MODIFICATION REQUEST:

Blocks 6 and 7, Central Park

MP 11_0091 MOD 1

Secretary's
Environmental Assessment Report
Section 75W of the
Environmental Planning and Assessment Act 1979

Figure 2: Proposed amendment to Level 5 of No. 2-10 Kensington Street illustrating location of ventilation added to northern facade (Source: Architectural plans from Proponent's Application)

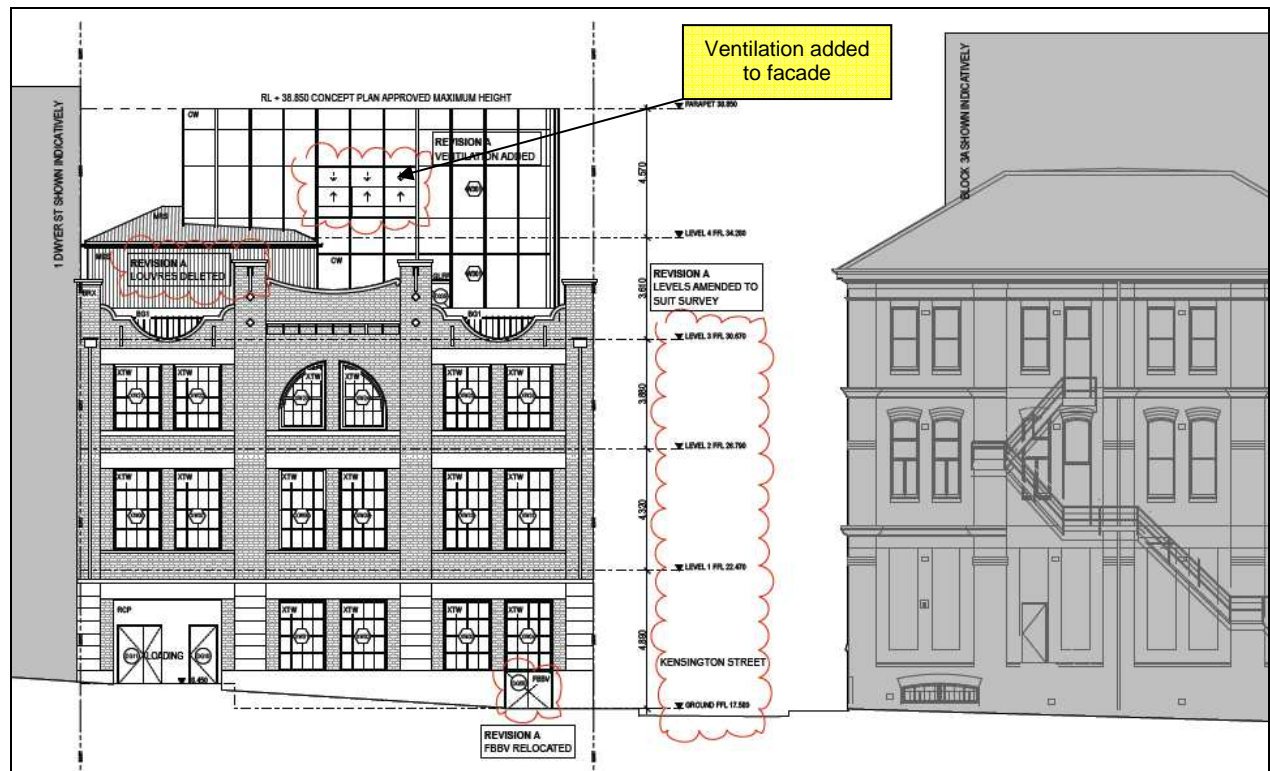
- inclusion of external ladders;
 - replacement of exterior wall to No. 12;
 - ventilation included within the glass screen to be constructed on No. 2-10 on Level 5;

Figure 3: Proposed amendments to ground floor of development (Source: Architectural plans from Proponent's Application)

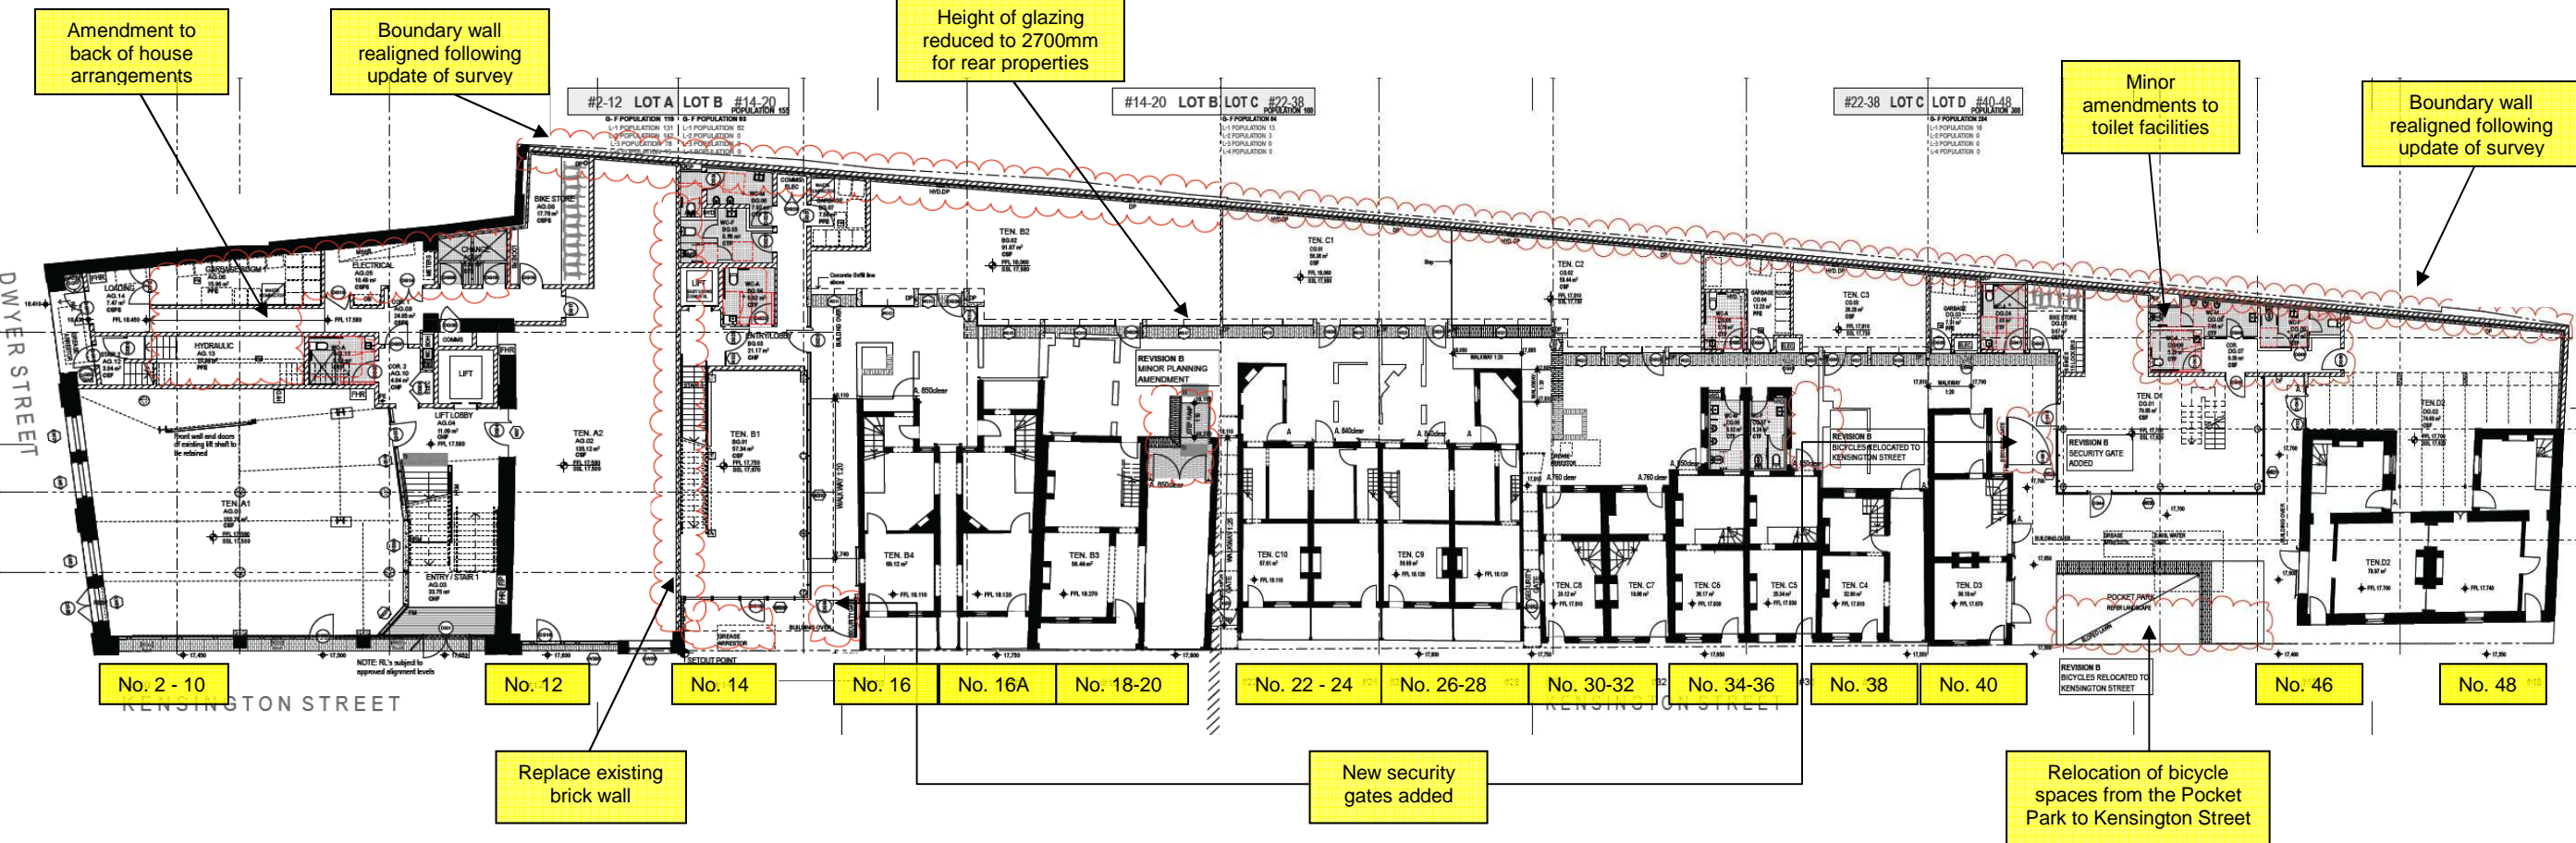
- internal amendments including:
 - changes to layouts of storage areas, services, bathroom facilities and access provisions;
 - reduction of the mezzanine level of No. 42; and

- replacement of an internal wall on the ground and first floor between No. 12 and 14.
- external amendments including:
 - realignment of the eastern boundary wall to correlate with an updated survey of the site;

The proponent seeks to undertake minor internal modifications to the approved development, as illustrated in **Figure 2** and **3**. These predominantly include modifications to bathroom facilities and plant rooms, which are proposed to improve the efficiency and access throughout the buildings and into the rear laneways. The department supports these minor modifications that provide greater access to these areas.

Figure 4: Proposed amendments to first floor of development (Source: Architectural plans from Proponent's Application)

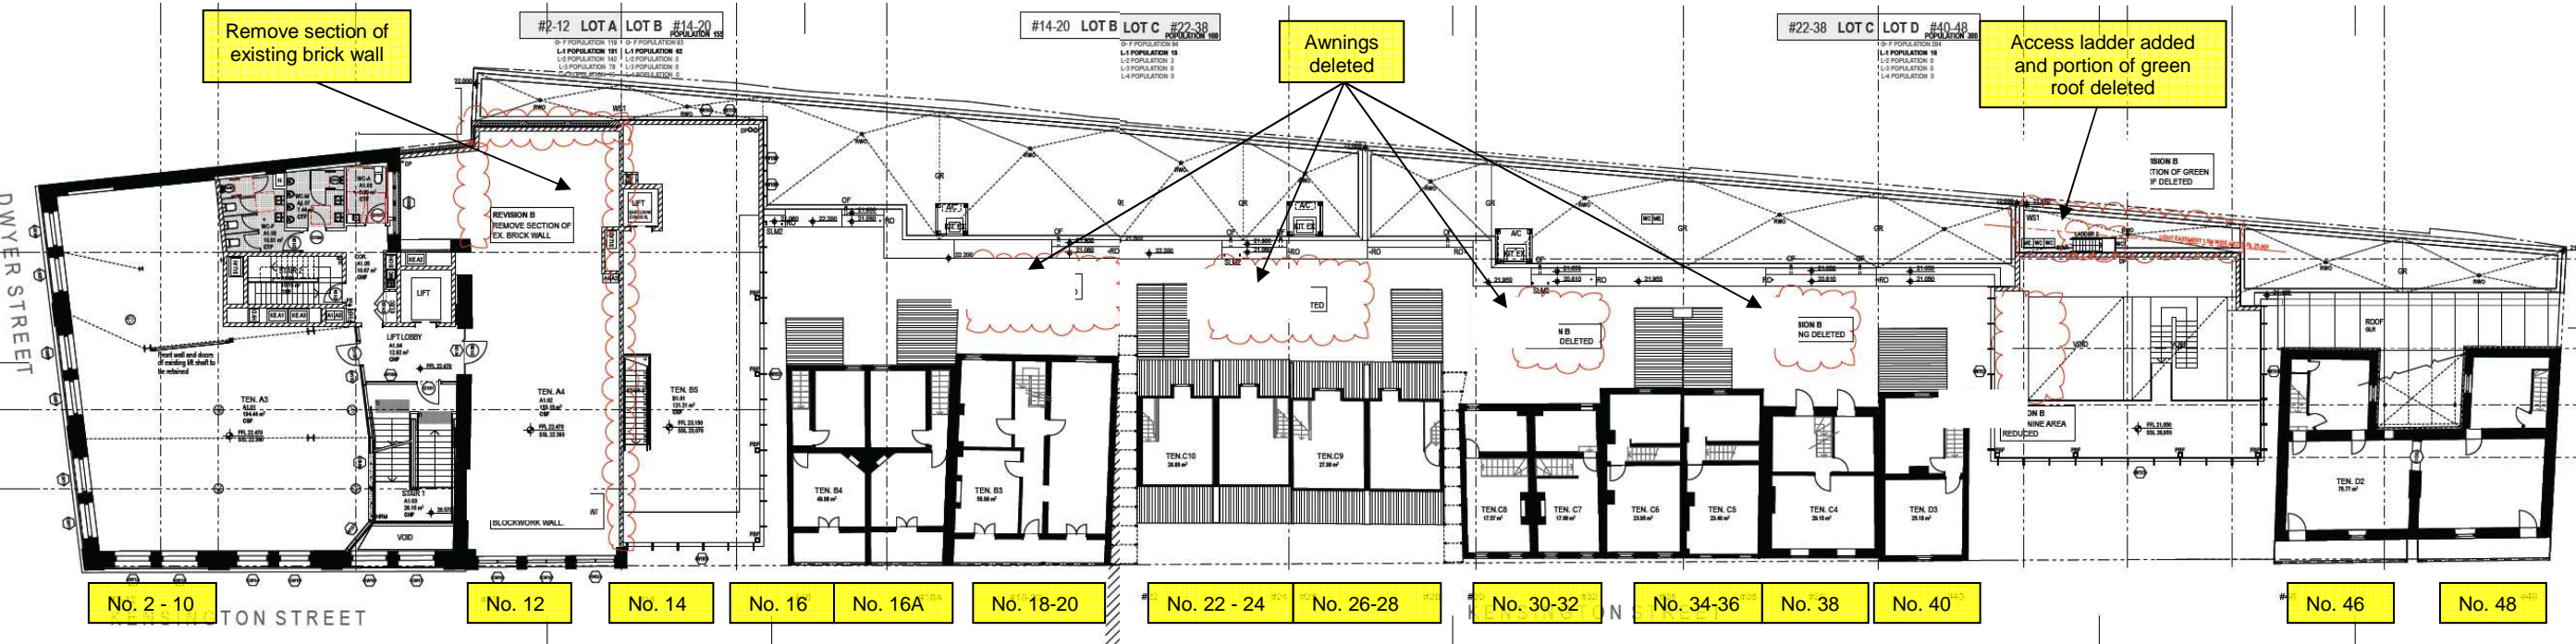
- increase the height of the glass parapet at No. 40-42 by 300mm (raising to a maximum RL 24.90);
 - the deletion of rear awnings and pergolas across all properties on Level 1;

Figure 6: Approved (left) and proposed (right) modifications to parapet height at No. 40-42 Kensington Street (Source: Proponent's Application)

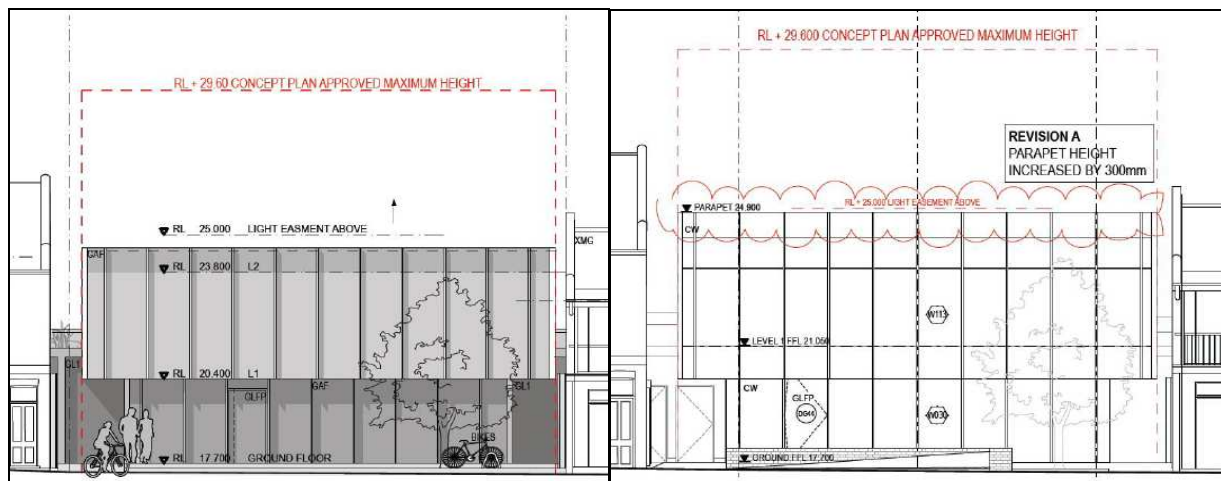
The proposed 300mm increase in height to the glass parapet height at No. 40-42 (raising to a maximum RL 24.90) will be visible from Kensington Street. A comparison between the approved and proposed elevation is provided at **Figure 6**. The increase in height of the parapet follows a refinement of the design to improve the appearance of the glass parapet to Kensington Street and ensure that it is of a similar height to the ridgeline of the buildings to the south.

The increase in height of the parapet does not impact upon the building light easement height of RL 25.00, which is provided to ensure light onto the Kensington Street public domain area. On this basis, the department supports this increase, noting that the minor increase will have minimal impacts on the external appearance and amenity of the Kensington Street public domain.
